# Twickenham Riverside

Response to feedback from  
meeting on 4th June 2021

12/07/21

Image showing awnings to the river end of the Water Lane building

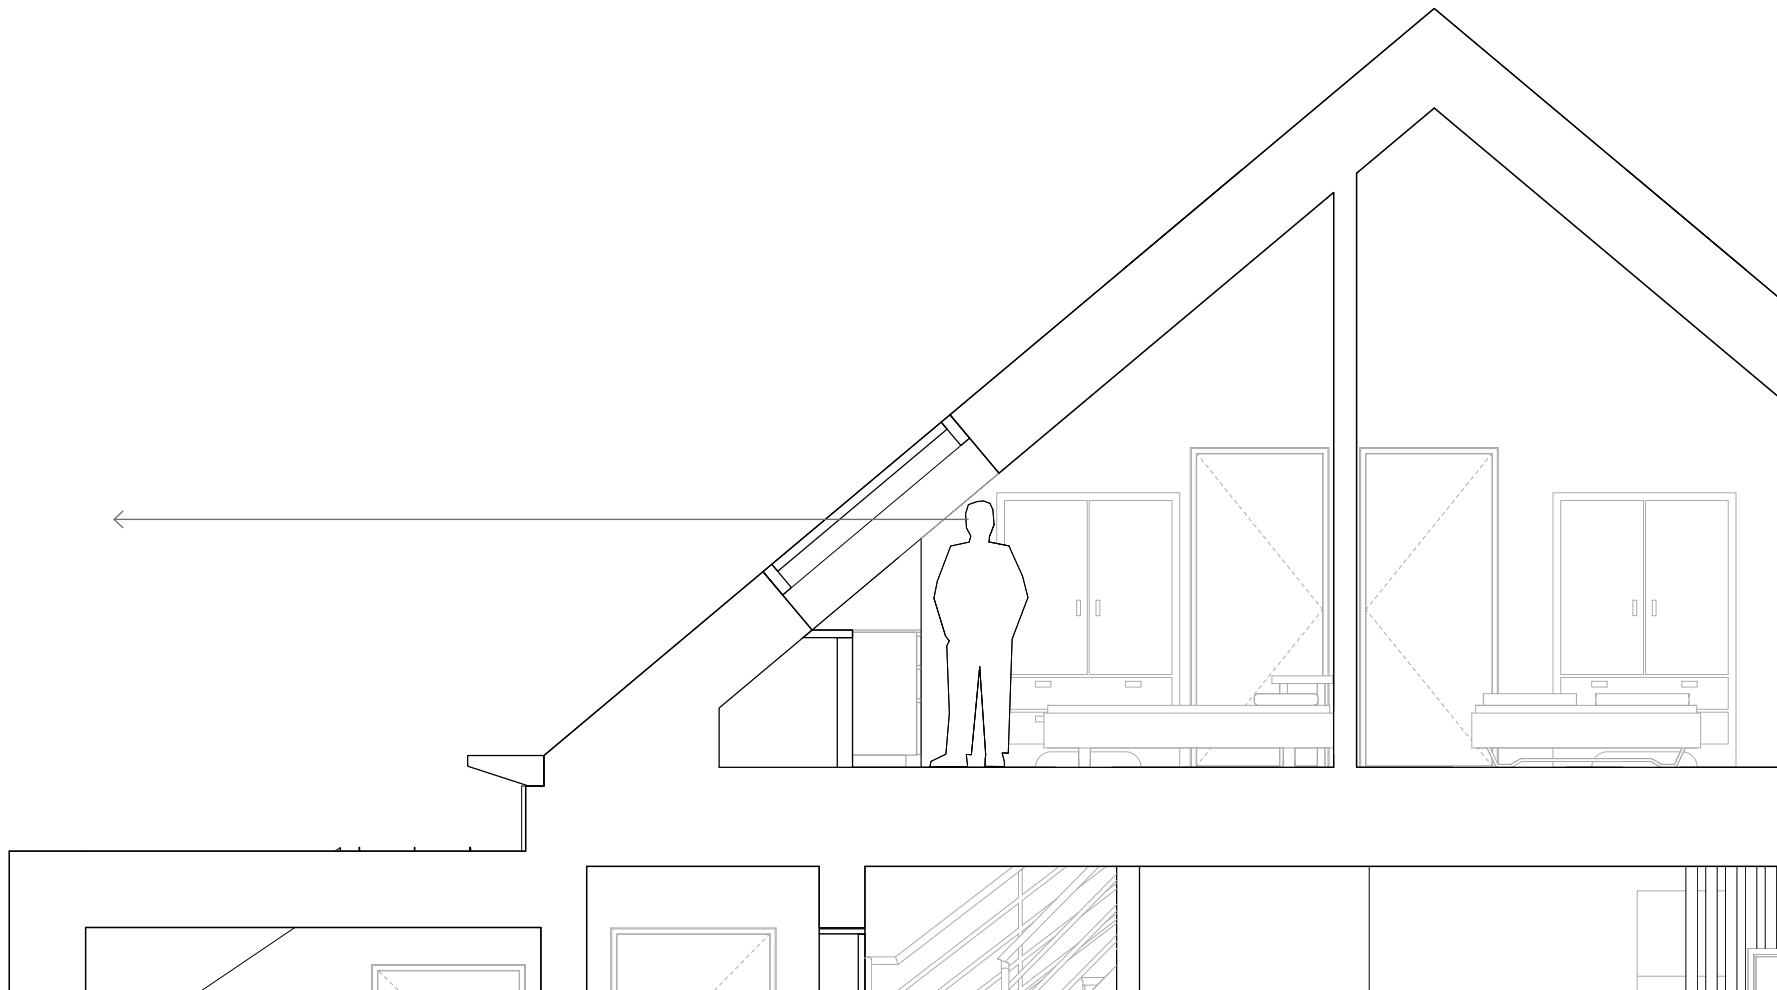
3. River elevation – request for greater glazing on the ground floor – we believe that there is already a significant amount of glazing to this café which will provide significant views out over the river and the gardens (see attached images from inside the café) – we do however agree with the suggestion for incorporating retractable awnings in the proposed glazing system and are looking to include this in the scheme for submission.

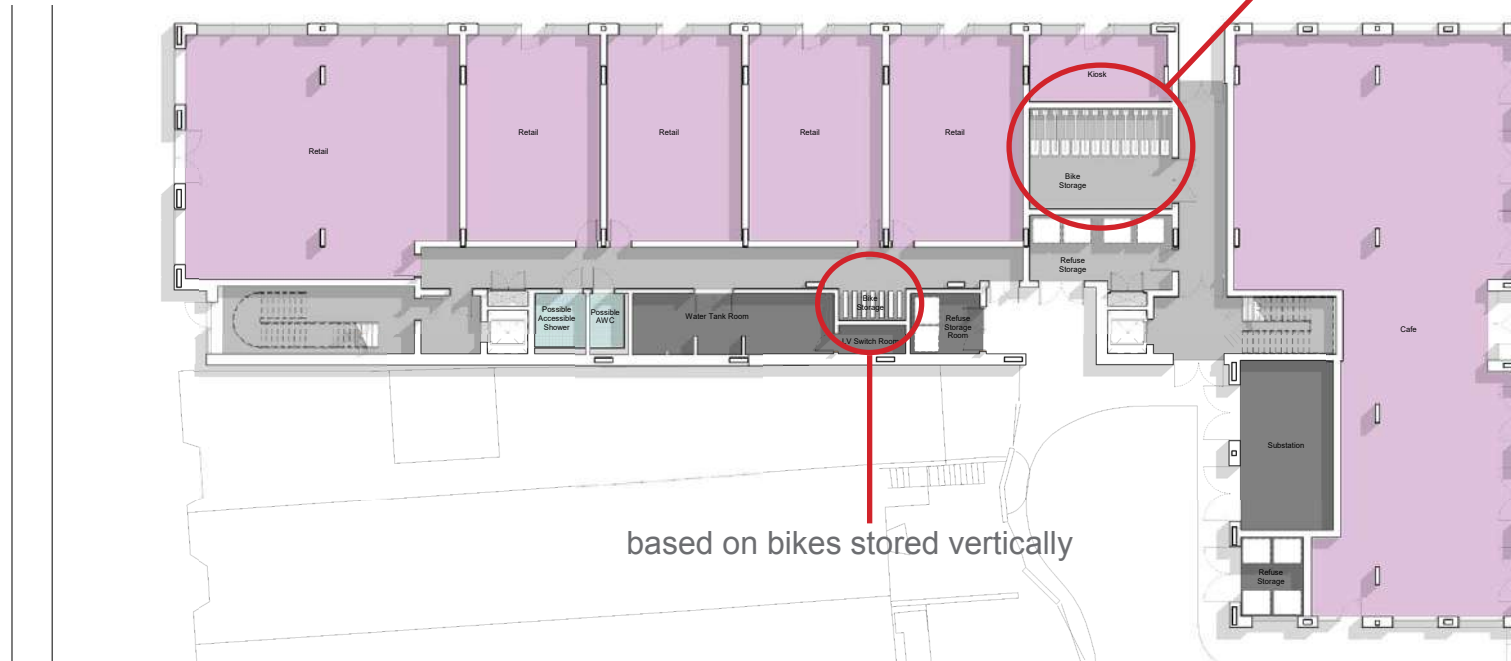
5. The bike store next to the water tank room in water Lane is based on cycles being stored vertically on wall hooks.

Section through Wharf Lane rooftop plant room - (Water Lane rooftop plant room similar)

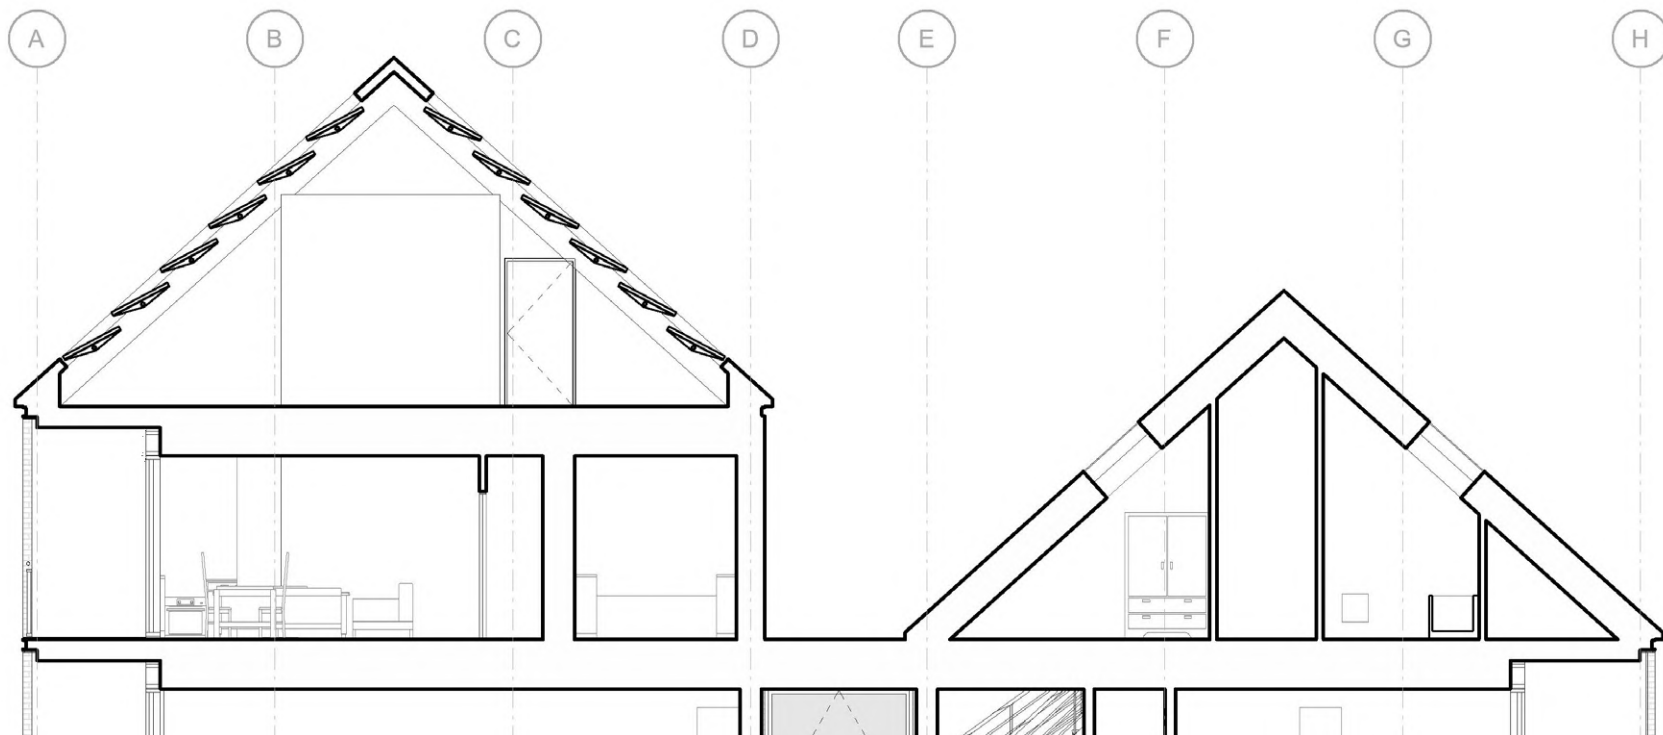
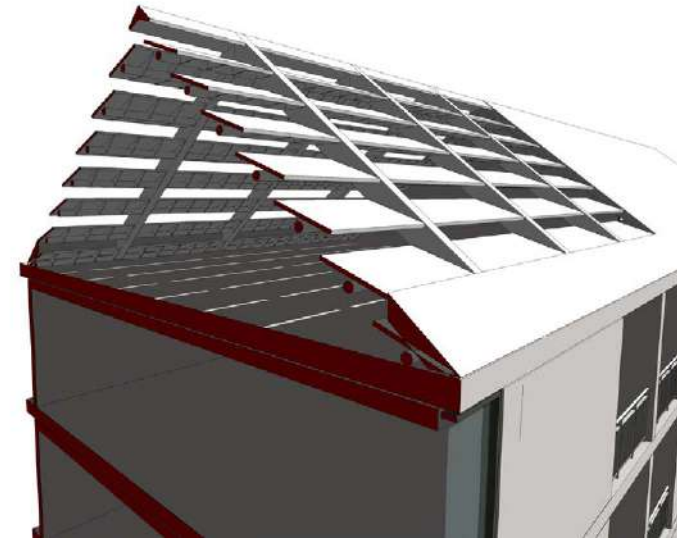
6. Please see attached section through roof plant room. The plant room is louvred on both sides to provide a good cross flow of ventilation to allow the air source pumps to work efficiently. The proposal is that the louvre blades are sized to support photovoltaic panels on the southern side. By placing the PV panels in this location it means that the cables connections can be checked safely from within the plant space rather than requiring access across the residential roofs and they can also be cleaned safely from within the plant room to maintain their efficiency.
